STATE OF CONNECTICUT
CONNECTICUT SITING COUNCIL

APPLICATION OF CELLCO PARTNERSHIP)	
d/b/a VERIZON WIRELESS FOR A)	
CERTIFICATE OF ENVIRONMENTAL)	DOCKET NO. 413
COMPATIBILITY AND PUBLIC NEED FOR THE)	
CONSTRUCTION, MAINTENANCE, AND)	
OPERATION OF A WIRELESS)	April 14, 2011
TELECOMMUNICATIONS FACILITY LOCATED AT)	
723 LEETES ISLAND ROAD IN THE TOWN)	
OF BRANFORD, CONNECTICUT)

NEW CINGULAR WIRELESS PCS, LLC ("AT&T")
RESPONSES TO TOWN OF BRANFORD INTERROGATORIES

Drive Test
(Driven Date: 01/21/2011)

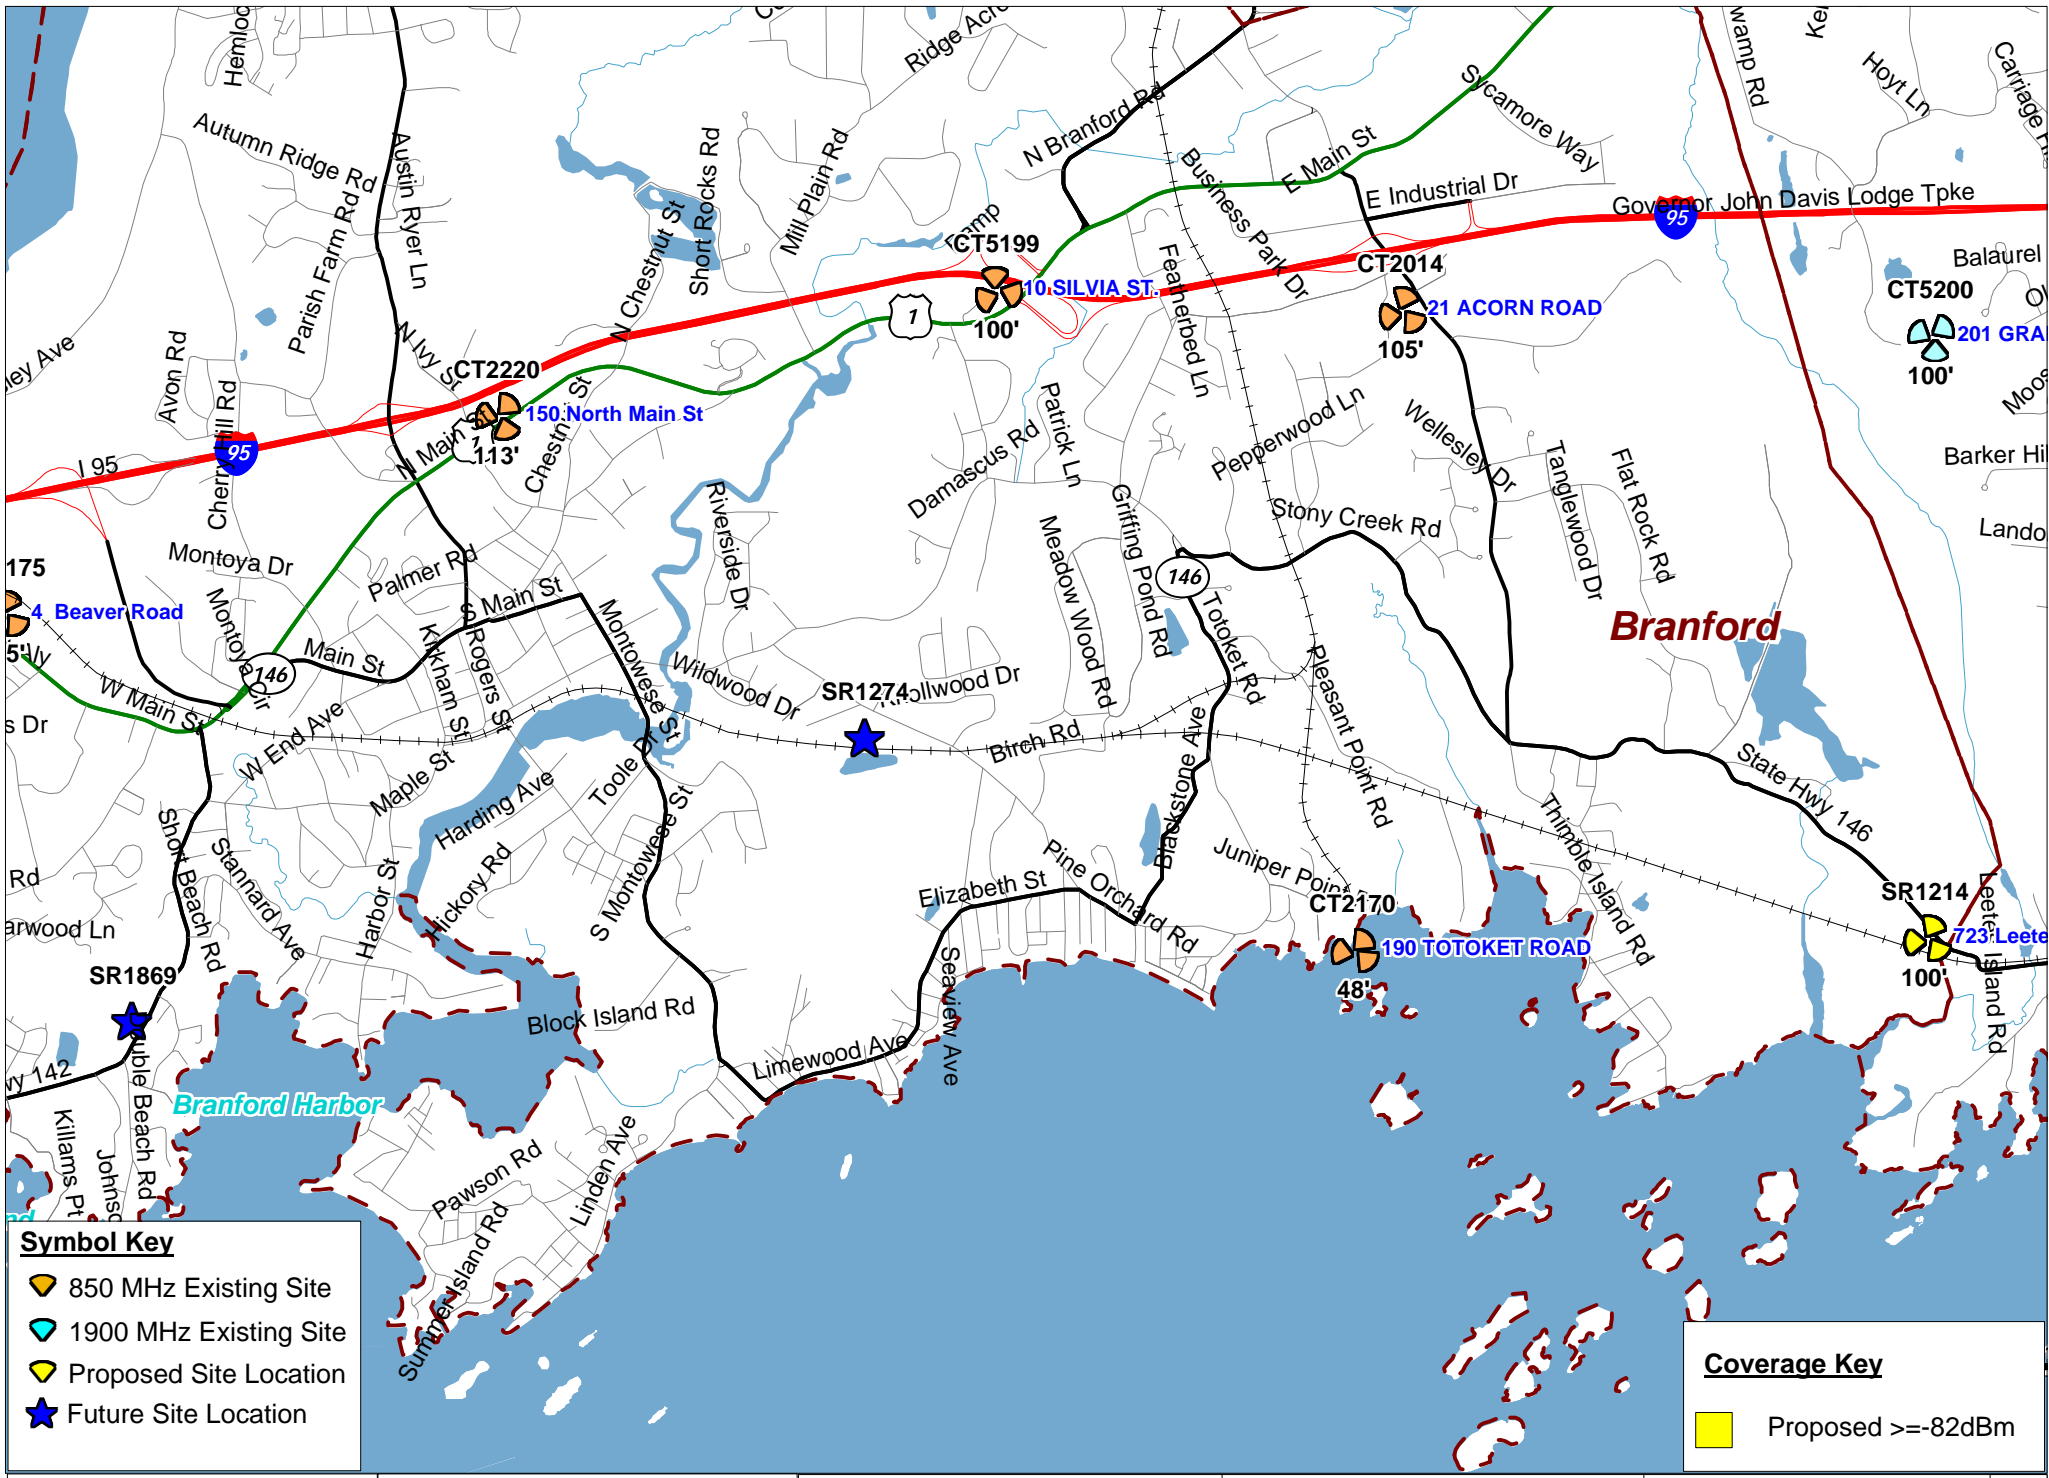
Q5. Were drive tests ("scan tests") that would verify the results of the calculated plots conducted? If so, please provide the data sets which were generated by the tests and note

whether the data needs to be corrected for variables including, but not limited to, antenna position, gain and line loss.

Q18. If you conducted any drive tests, please produce the results of those drive tests?

A5. A drive test of existing coverage was performed. A plot of this drive test is included in Attachment 2.

A18. Please see A5 and Attachment 2.

Existing, Proposed & Future Site Locations

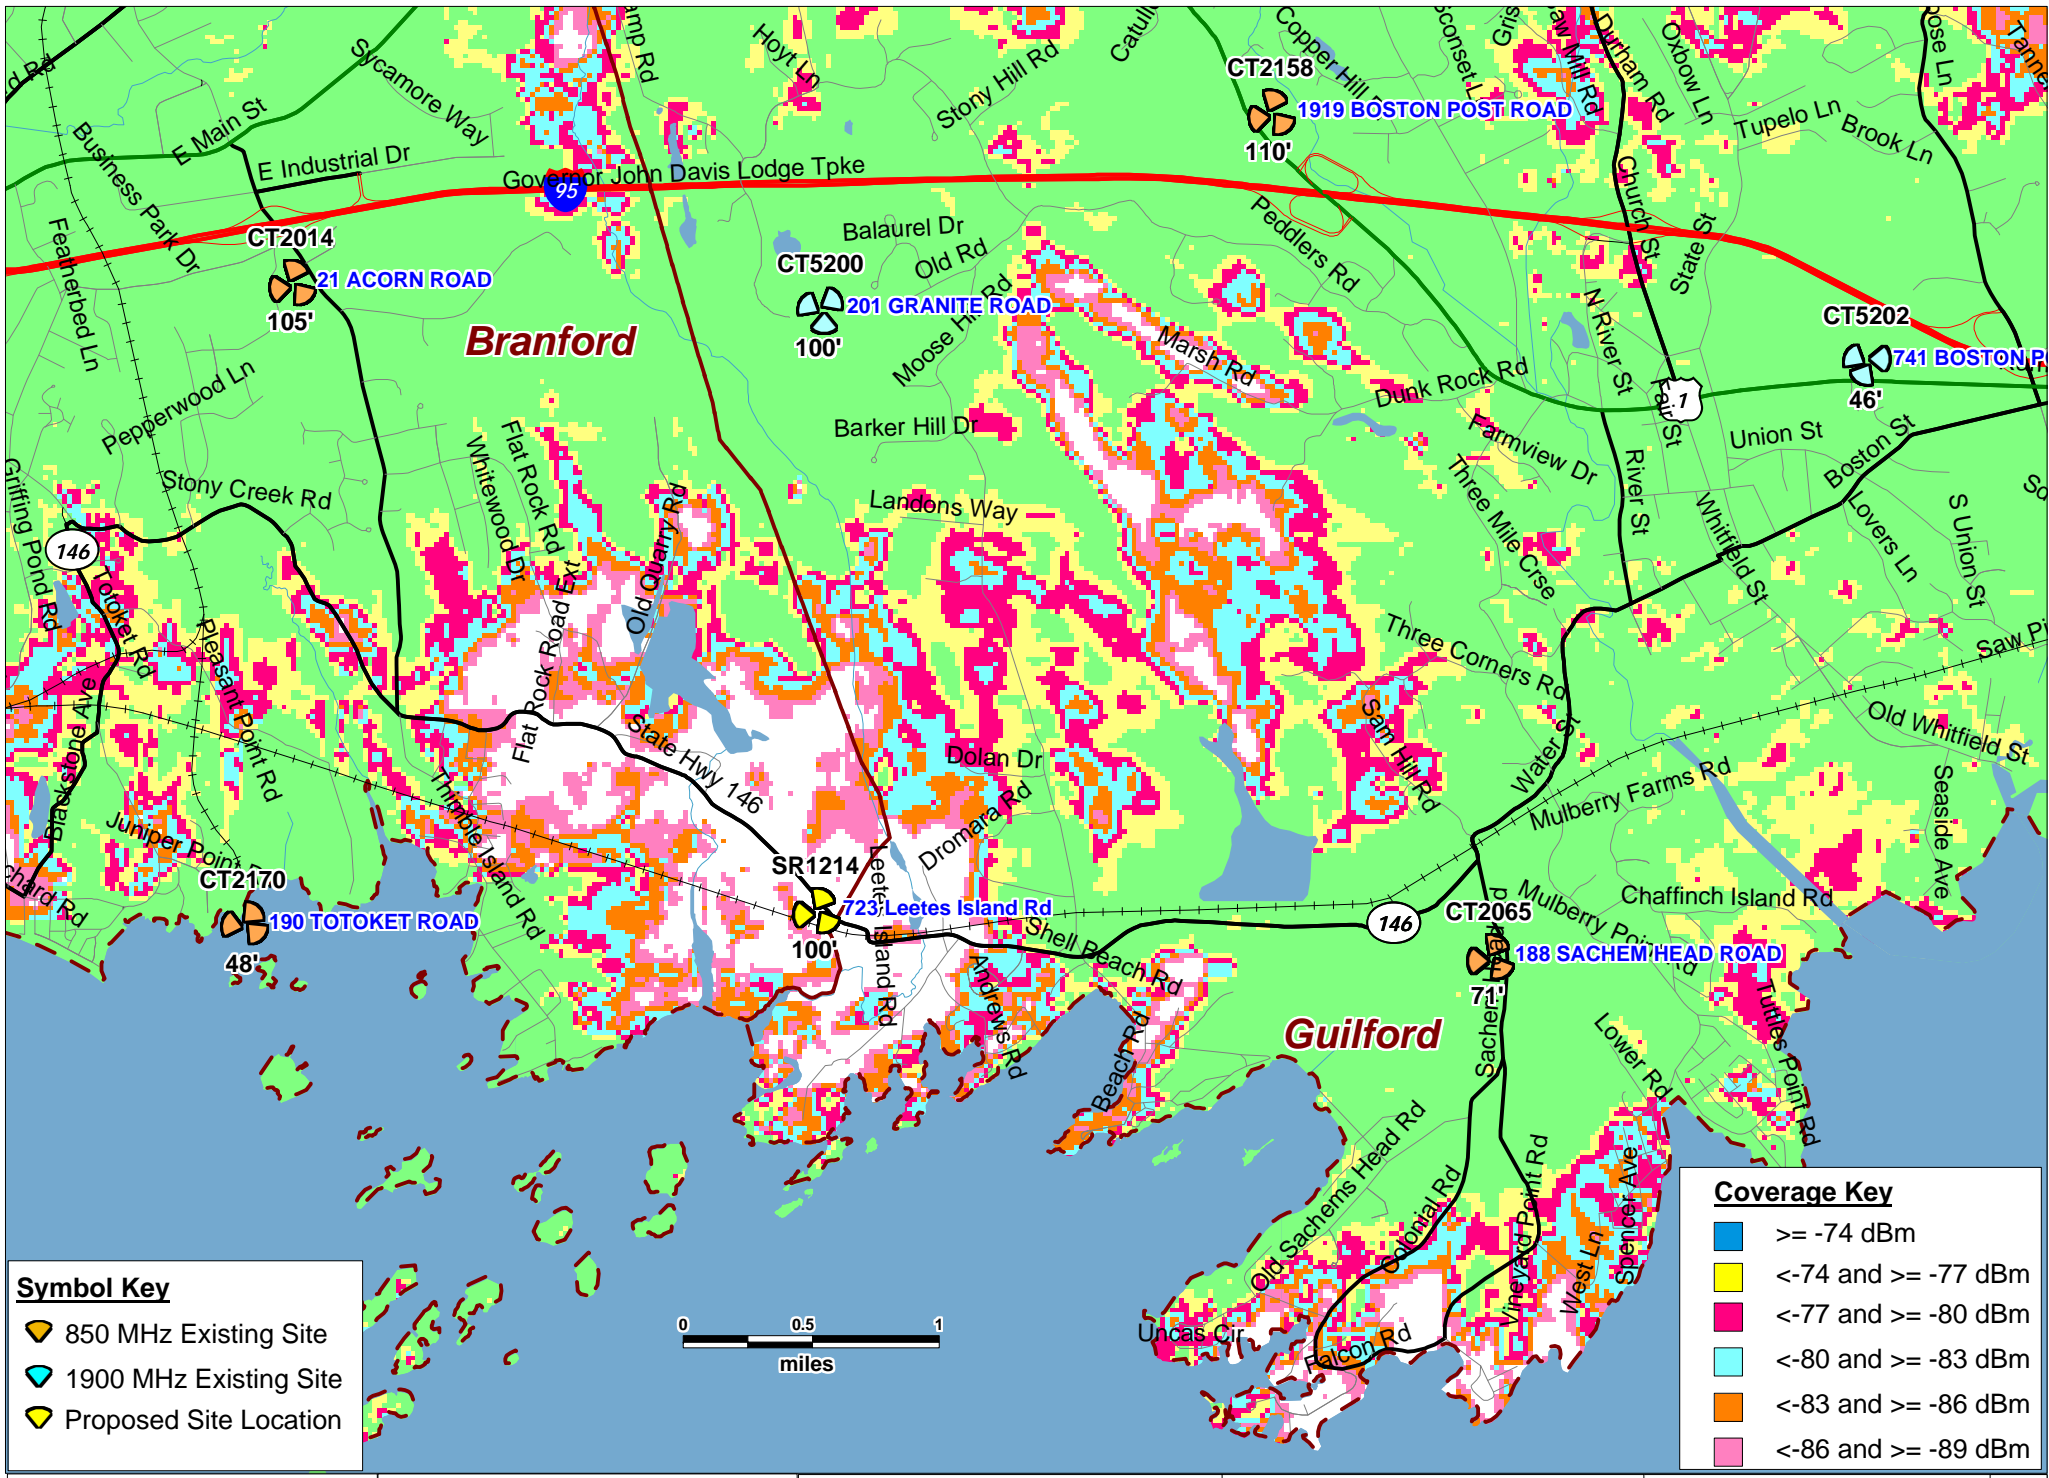
Q14. Are there other sites in Branford at which you are considering developing wireless communications facilities? Please describe.

A14. Yes. AT&T will co-locate on the 125' monopole under construction at 123 Pine Orchard Road (Docket No. 386) and install antennas at a centerline height of 112' AGL. AT&T, in conjunction with North Atlantic Towers, is proposing a facility at 171 Short Beach Road. A map showing of the locations of these sites and existing AT&T sites is included as Attachment 3.
